ENGINE - OIL - PROVIDE AN IMPROVED SIGHT GLASS - CATEGORY CODE 7 - MOD.ENG-79-0030

V2500-ENG-79-0030

SCREW TORQUE SEQUENCE  
Fig.1

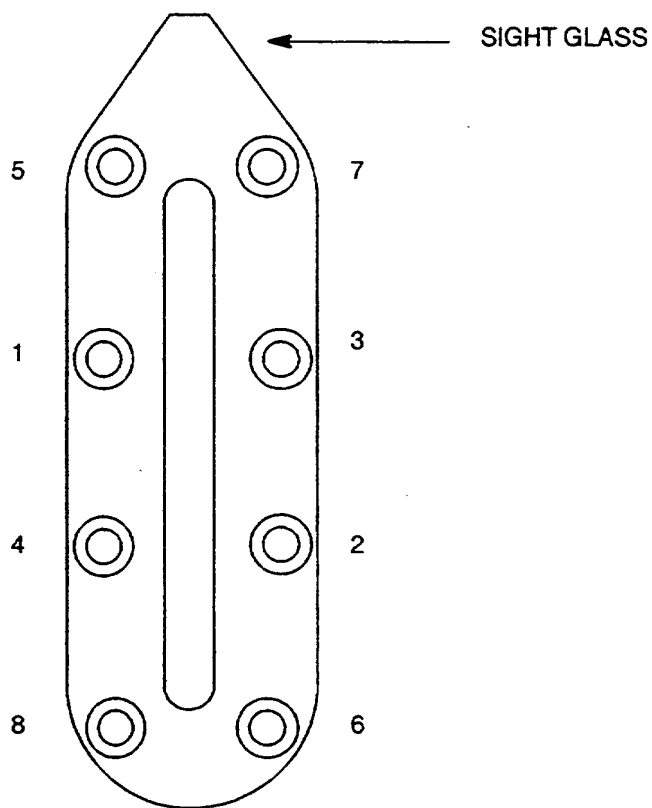
- (1) Remove the sight glass 4T7921
  - (a) Remove and discard the TORX5703-10 screws (8 off).
  - (b) Take out and discard the 4T7921 sight glass and the 4T7921-02 gasket
- (2) Install the new 4T7926 sight glass
  - (a) Place the new 4T7926-02 gasket and the new 4T7926 sight glass.
  - (b) Place 4T0510 screws (8 off) in their seats and make sure you engage properly the helicoil
  - (c) Run down the screws in a cross sequence from No. 1 to 8 until they are seated. See Figure 1.
  - (d) Torque the screws, always in the correct sequence, to between 27.0 and 29.0 lbfin (0.305 to 0,327 md.N)

RUN DOWN AND TORQUE THE SCREWS IN THE SEQUENCE FROM 1 TO 8
